### **REMARKS/ARGUMENTS**

### **Amendments to the Drawings**

FIG. 30

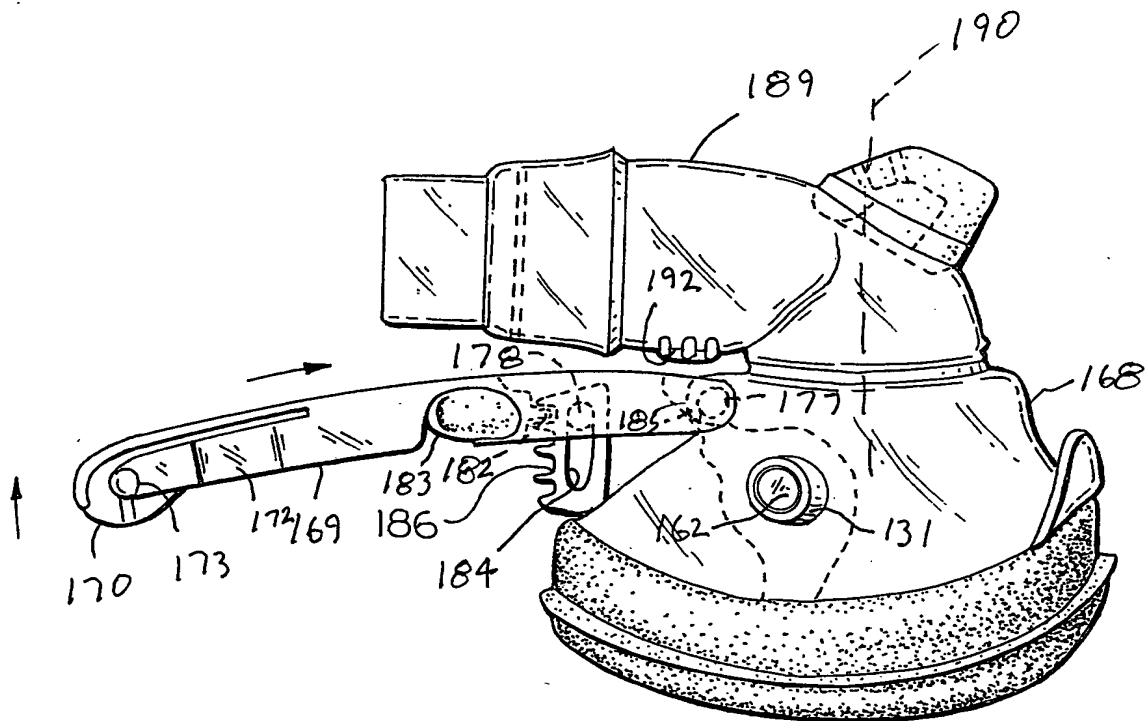
In paragraph 3 of the office action, the drawings were objected to for failure to show several reference numbers. Reference numbers were mistakenly omitted from Figs. 30 and 31 of the drawings. A replacement page 15 of the drawings is submitted herewith with the reference numbers added. In view of the amendment to Figs. 30 and 31 of the drawings, withdrawal of the objection is requested.

The attached sheet 15 of drawings includes changes to Figs. 30 and 31. In Figs. 30 and 31, previously omitted reference numbers has been added.
